Notice of Allowability	Application No.	Applicant(s)	
	10/506,589	FREUDENBERG ET AL.	
	Examiner Lan Nguyen	Art Unit 3683

REASONS FOR ALLOWANCE

Fig-1

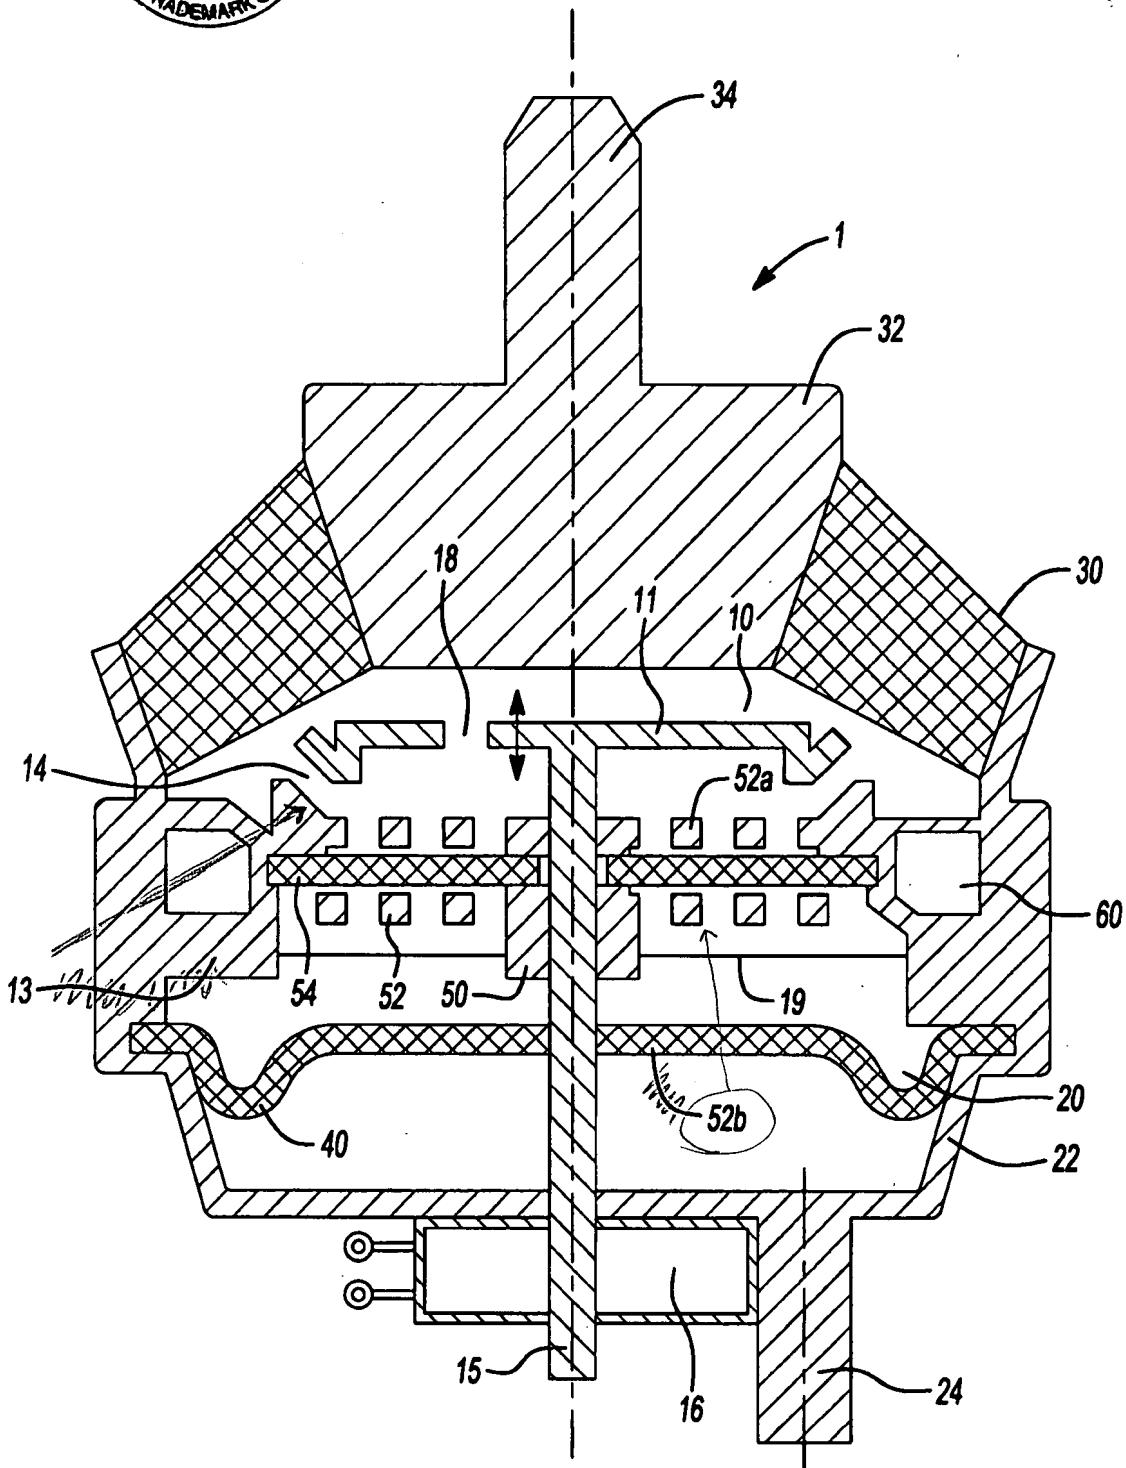
2. The drawings received 6/8/07 are not approved. Elements 13 and 52b point to the wrong parts. Please correct.

NOT
approved
XLN 7/24/07

Fig-2B

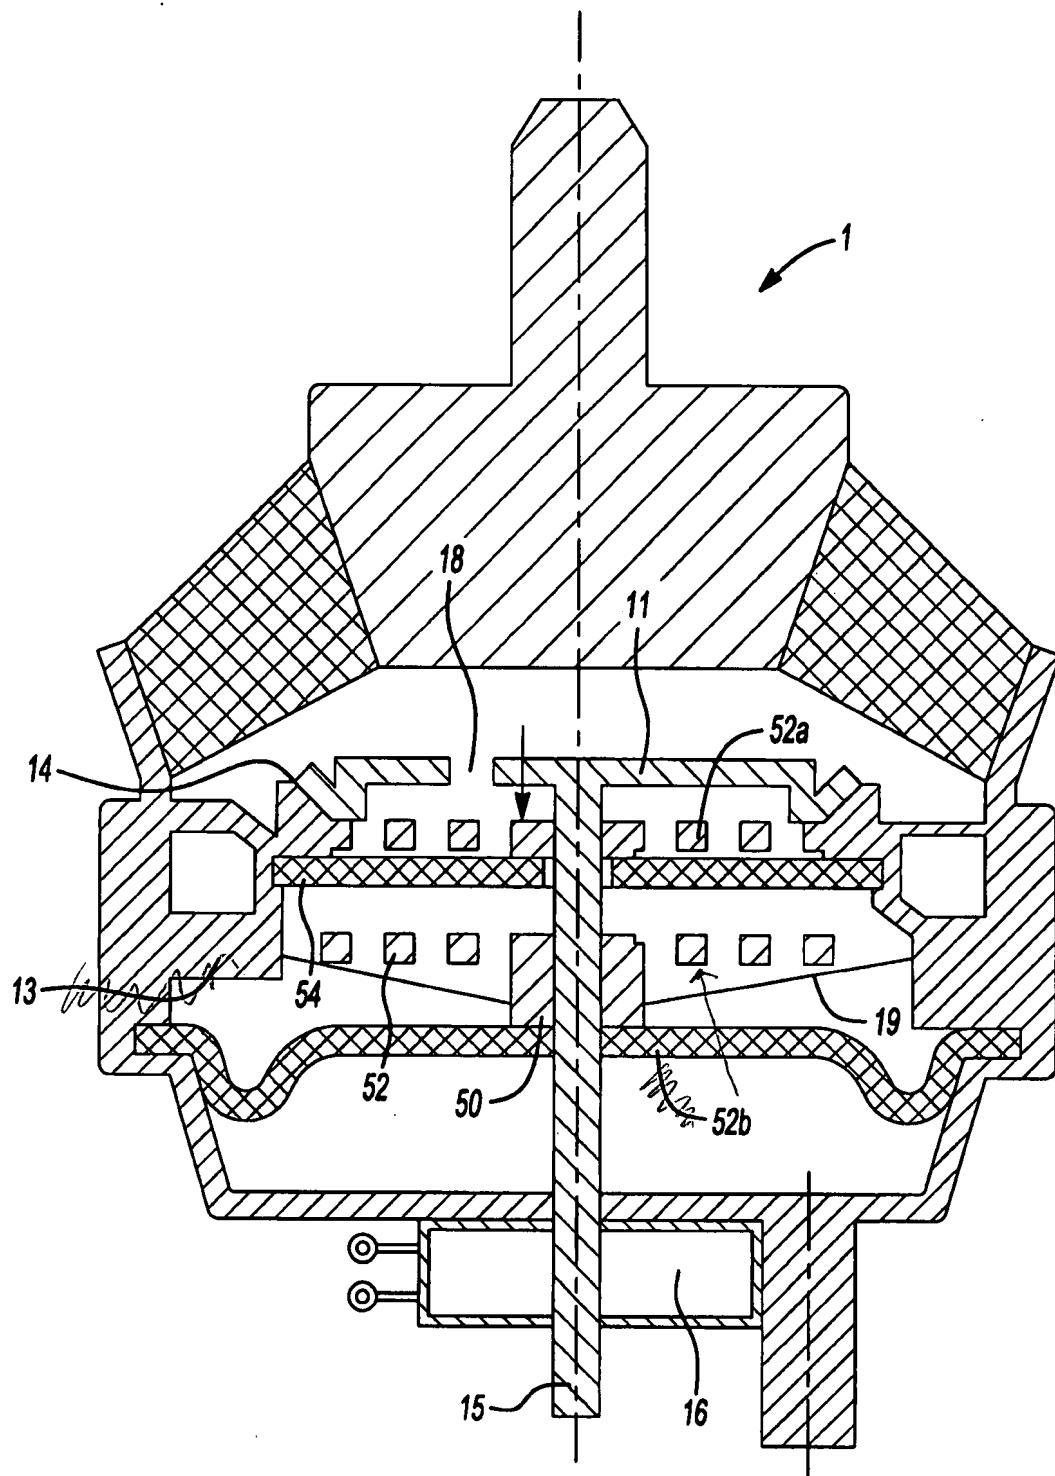
NOT
approved
7/24/07
XLN
